Device-Product Review Memorandum

BLA 125722.0

Title: Eladocagene Exuparvovec for the Treatment of Aromatic L-amino Acid Decarboxylase (AADC) Deficiency

Route of Administration and Delivery Device: intraputaminal with the ClearPoint Neuro Smartflow MR Compatible Ventricle Cannula

SmartFlow Cannula Construction

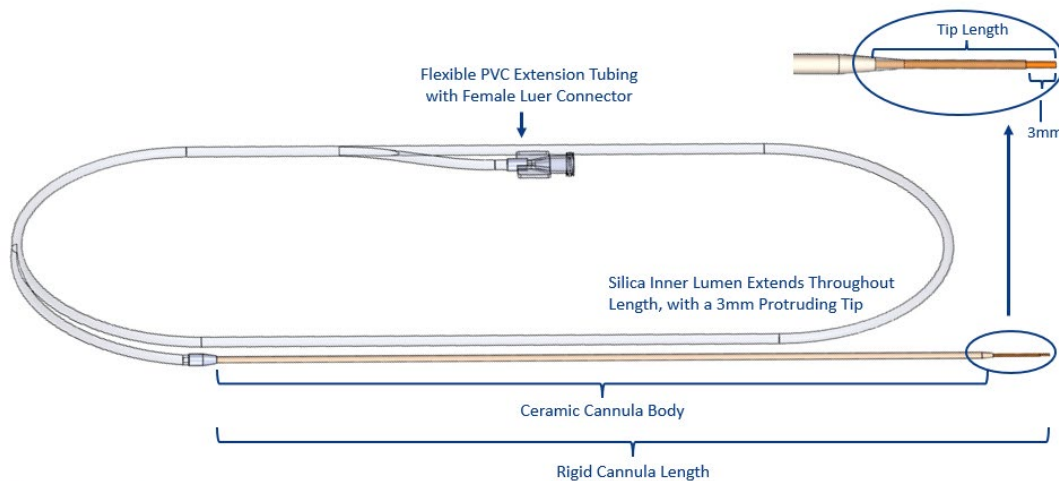
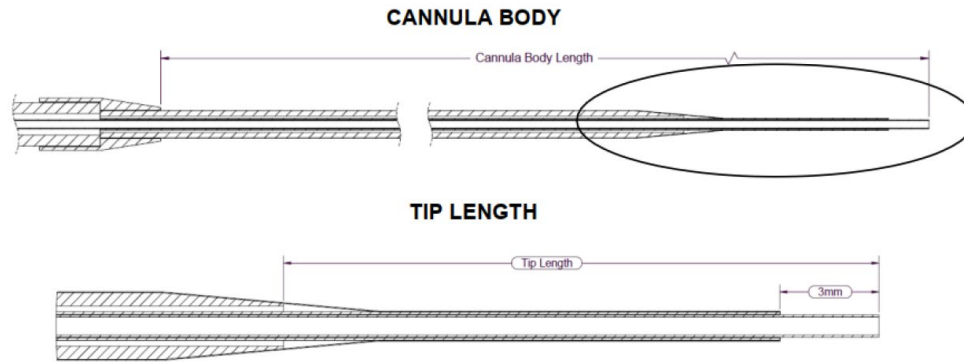
The applicant indicates throughout Module 3.2.R.3 that the composition, dimensions, and physical properties of the SmartFlow Cannula are referenced from the (b) (4) (held by ClearPoint Neuro) for the SmartFlow Cannula Device. However, the information from (b) (4) is not completely reflective of the SmartFlow Cannula version that will be cross-labeled with the DP under this BLA – this is because (b) (4) is a device MAF that contains information pertaining to various ventricular cannula configurations and versions of the SmartFlow Ventricular Cannula device that may not be applicable to the cross-labeled cannula design.

Although the applicant and device manufacturer both indicate that the SmartFlow Cannula to be included in the de novo request submission is essentially the same as the device cleared under K102101, the cross-referenced (b) (4) contains several significant amendments with updated design control information for the SmartFlow cannula that were submitted to CDRH in October 2021 and October 2023. It appears that the SmartFlow cannula device design control information has been updated since K102101 clearance review.

Hence, only relevant information pertaining to the cross-labeled SmartFlow Cannula from DEN240023 should be referenced/reviewed to support cross-labeling with eladocogene exuparvovec.
